REMARKS

Claims 1-23 are all the claims pending in the application. New claims 14-23 have been added as a copy of the claims from US Patent 6,290,147, for the purposes of eventually provoking an interference therewith. Reconsideration and allowance of all the claims are respectfully requested in view of the following remarks.

Fig. 3

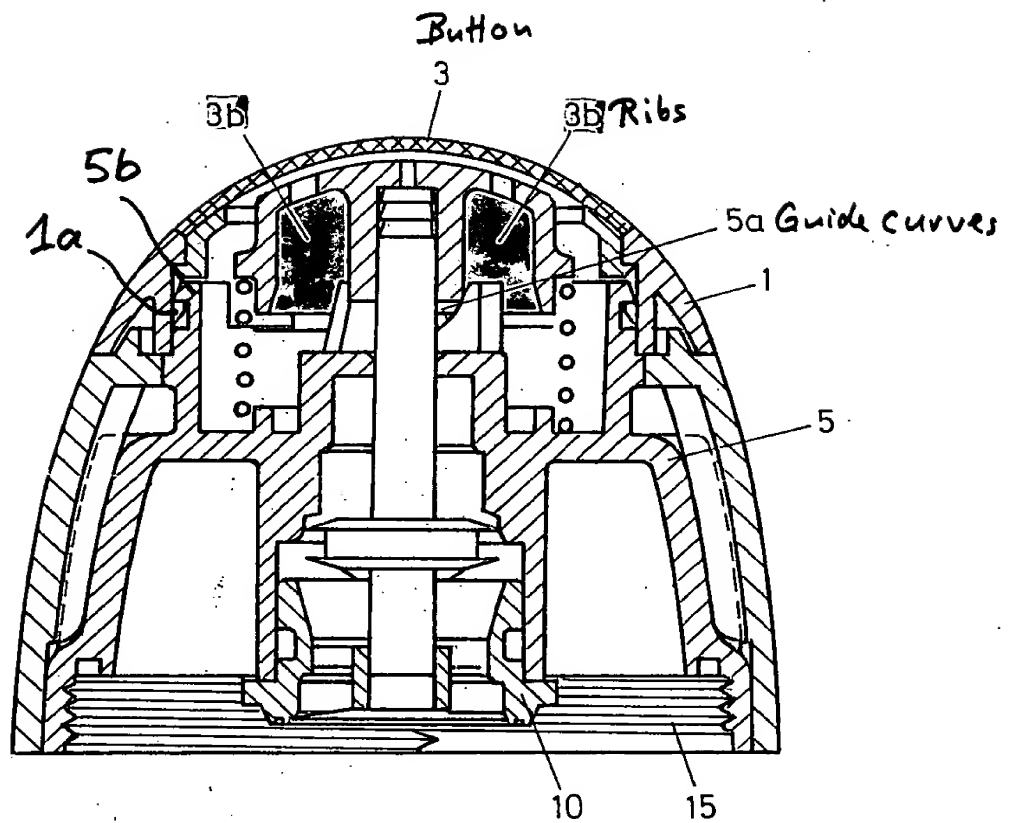
- The Examiner objected to the drawings as including certain reference signs not mentioned in the specification. Accordingly, Applicant has amended the specification to include the noted reference signs "1a", "5b", and "3c". No new matter has been entered.
- Further, the Examiner objected to the drawings as not showing every feature of the invention specified in the claims. Specifically, the Examiner asserted that "the 'reset mechanism' (two ribs 3b and the guide curves 5a and stop cam 5f) recited in claims 1, 8, [and] 9" must be shown. Applicants respectfully traverse this objection because the reset mechanism is, indeed, shown in the figures.

The ribs 3b and guide curves 5a are shown in Figs. 1-3, whereas the stop cam 5f is shown in Fig. 2. For the Examiner's convenience, submitted herewith is a copy of Figs. 1-3 wherein the ribs 3b are highlighted in blue, the guide curves 5a are highlighted with yellow, and the stop cam 5f is highlighted in pink.¹ The function of these elements is disclosed on page 5, lines 12-15, for example. When the button 3 is rotated, the ribs 3b are pressed to the guide curves and the button

3 is moved upwards. The spring 7 supports this upward movement. Thus, the drawings clearly show the reset mechanism, including the parts noted by the Examiner.
